**Item 3**
**8 Western Crescent, Gladesville - LDA2021/0300**

**Construction of a nine storey mixed-use development comprising 32 residential apartments, ground floor community facility (commercial) floorspace with four levels of basement carparking with 66 spaces.**

**City of Ryde  
Local Planning Panel Report**

<b>DA Number</b>	LDA2021/0300
<b>Site Address &amp; Ward</b>	8 Western Crescent, Gladesville Lot 1 DP 1242260 East Ward
<b>Zoning</b>	B4 Mixed Use
<b>Proposal (as amended)</b>	Construction of a nine storey mixed-use development comprising 32 residential apartments, ground floor community facility (commercial) floorspace with four levels of basement carparking with 66 spaces.
<b>Property Owner</b>	Gladesville RSL and Community Club Limited
<b>Applicant</b>	Geron Property No. 6 P/L
<b>Report Author</b>	Shannon Butler – Senior Town Planner
<b>Lodgement Date</b>	31 August 2021
<b>Notification - No. of Submissions</b>	Thirty (30) submissions received in objection.  During the second notification period, thirteen (13) submissions received objecting to the development.

**Figure 21** – Original ground floor plan on the left and ground floor plan as amended on the right

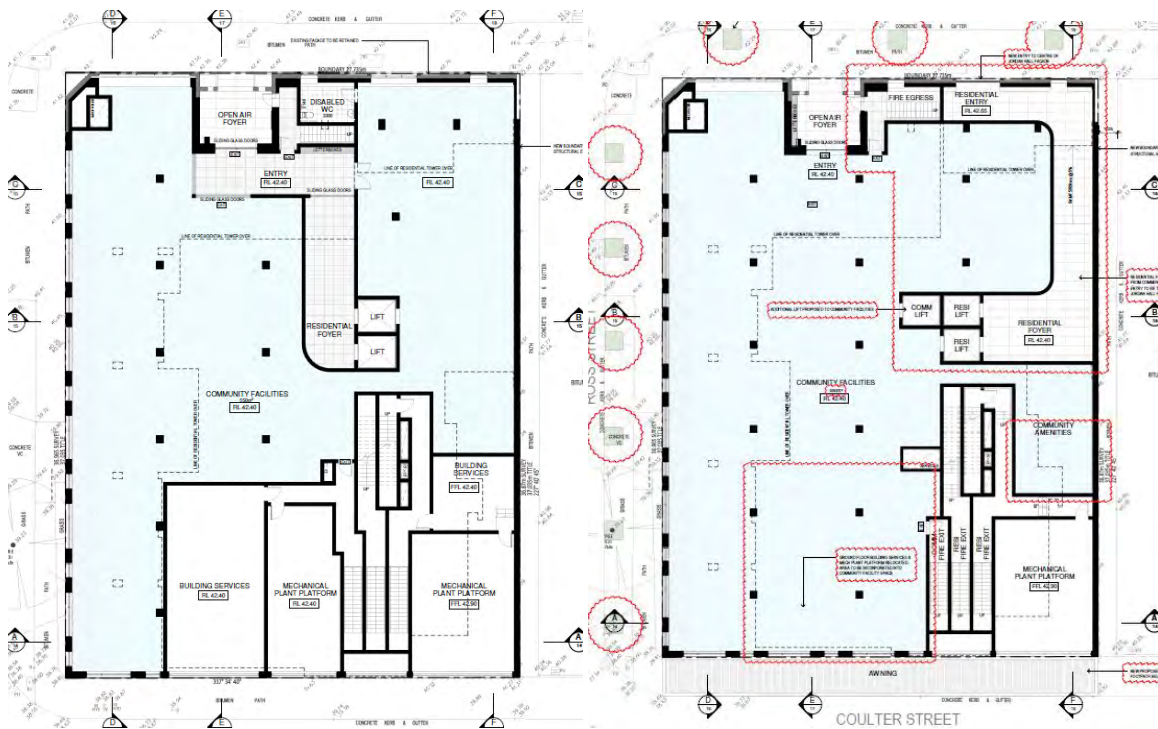
*The primary residential address has been relocated from Coulter Street to Western Crescent, which is supported in principle. However, the detailed planning of the residential and community uses - both coinciding with the original front entry to Jordan Hall - is convoluted and inefficient for both uses. The community uses are rendered less flexible due to the residential lobby, which splits the community tenancy in two.*

*The community uses should be studied in greater detail to illustrate potential configurations and to demonstrate the resulting floor to ceiling heights where structure and services will constrain this. The Panel notes that re-planning the residential lobby will significantly improve the community space through consolidation.*

The proposal was amended to increase the floor to ceiling height of the ground floor community facility floorspace from 3.3 metres to 4 metres. The ground floor building services and mechanical plant platform were relocated with space being incorporated into the community facility floorspace. The amended design includes an additional dedicated lift and amenities space to support functionality of the proposed ground floor use. Further, the design was amended to include a designated area for amenities (kitchen/toilets) for the community facility floorspace. The amended proposal was referred back to the UDRP for comment and was supported with regard to context and neighborhood character.

Following the recommendations of the UDRP, a new residential entry has been introduced to the Western Crescent façade. The residential foyer is also separated from the community space and located towards the eastern boundary of the site (**Figure 21**). The Jordan Hall façade is still retained through the amended design. This is achieved through maintaining appropriate scaling, proportion and symmetry of the existing brick façade. The blank wall adjoining the Council car park incorporates pre-cast panel with a pre-colored finish for articulation of the façade.

Figure 23 – Extract of level 6 floor plan showing bedroom window highlighted in yellow which is on an oblique angle to the common circulation area window also highlighted in yellow

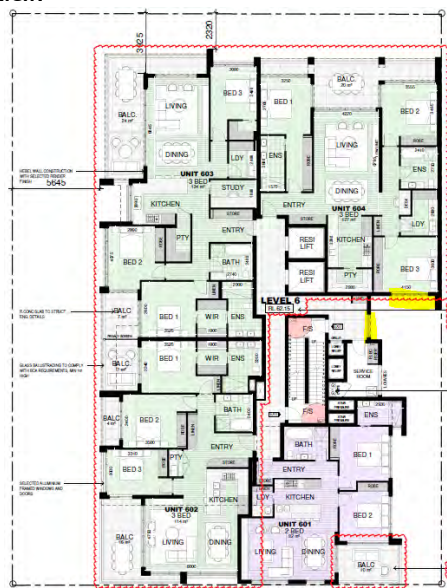
*Units 104, 205, 305, 405, 505, 702, 802 and 902 all bring bedroom windows close to the window serving the common circulation corridor on each level. Some re-planning is encouraged to improve the available outlook from the affected bedrooms (particularly Bed 3 in Units 702 and 802), and to eliminate any potential from cross viewing from bedroom to corridor.*

The bedroom 2 windows for Units 104, 205, 305, 405 and bedroom 3 windows for Units 504, 604 and 703 are located in close proximity to the window serving the common circulation corridor on each level. Cross viewing is minimised by orientating the circulation windows over the side boundary and away from these bedroom windows, thus resulting in an oblique angle to those bedroom windows (**Figure 23**). Both uses are low-level, and this is considered an acceptable outcome. Unit 802 includes a new balcony, to provide greater solar access and ventilation to bedrooms, in close proximity to the window serving the common circulation corridor. The glass opening is proposed to be obscure to minimise overlooking potential.

Figure 30 – Proposed ground floor plan (as amended)

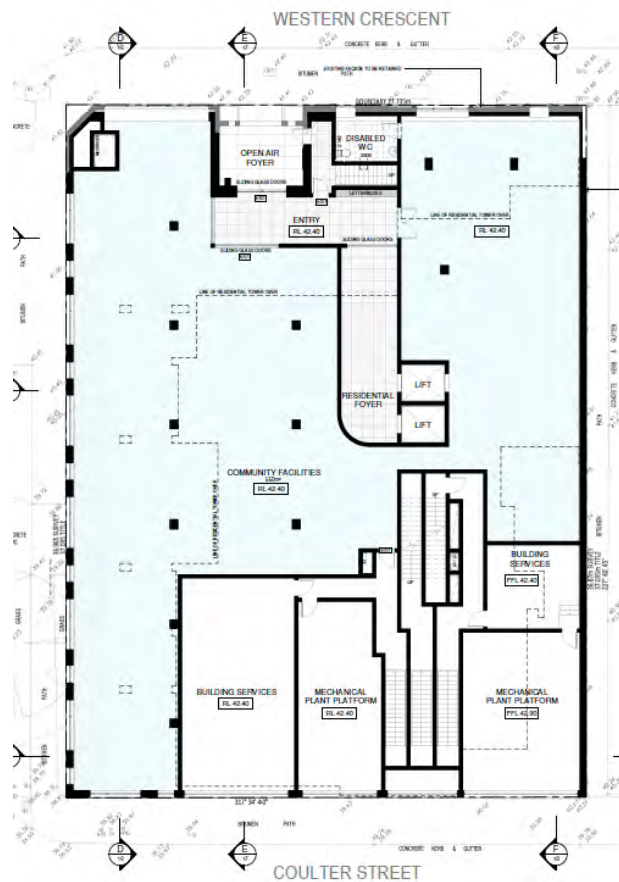
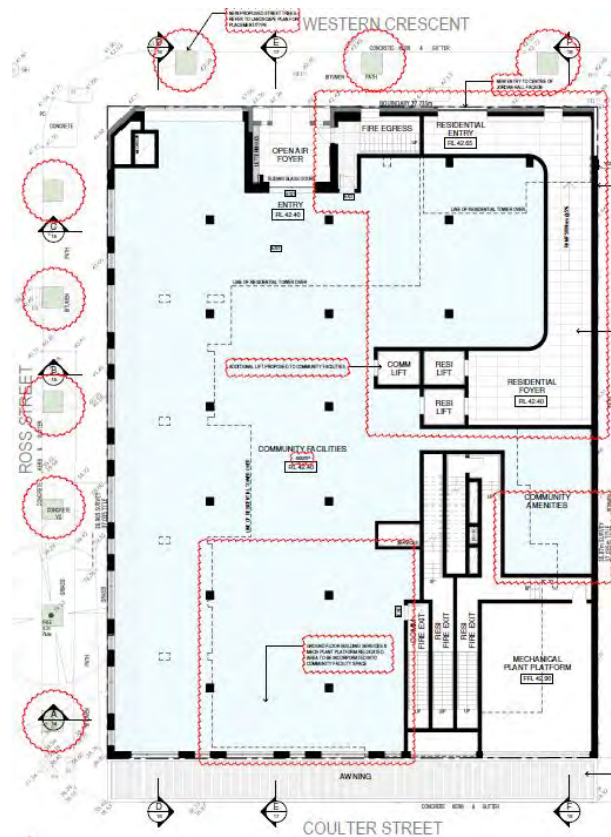
In the previously approved development, the residential pedestrian access was also located on the ground floor, off Western Crescent. In this development, the residential entrance was co-located with the community facility entrance by way of the existing door opening in the Western Crescent façade. It is considered that the residential entrance as approved was convoluted and inconvenient as it intersected the community facility floorspace and did not effectively separate the two uses (**Figure 28**).

The revised floor plan for the ground floor has been submitted due to the UDRP raising concerns with the originally submitted floor plan as shown in **Figure 29**. From an urban design perspective, the separation of the residential lobby and community facility entries, as shown in **Figure 30** is supported. The amended design results in the community facility floorspace being more contiguous than the original scheme and will result in an improved user experience for the occupants of the residential units.

Figure 34 – Block 18 Built Form Plan (subject site denoted by black circle)

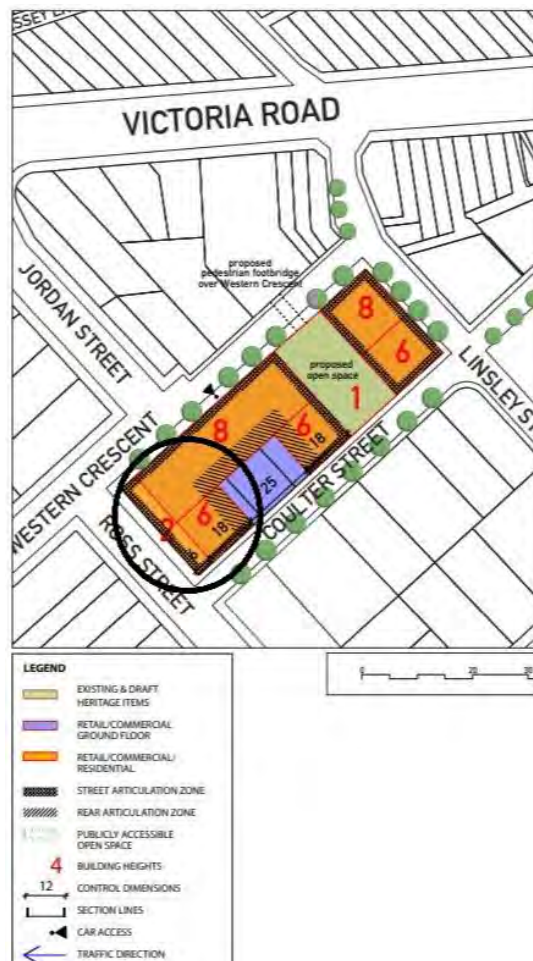
The proposal does not not comply with the number of storeys shown in the Key Site Diagram. The Key Site Diagram for the site requires 8 storeys along Western Crescent, 6 storeys along Coulter Street and 2 storeys along Ross Street for a depth of 6m. The development proposes 9 storeys along Western Crescent and 7 storeys along Coulter Street.
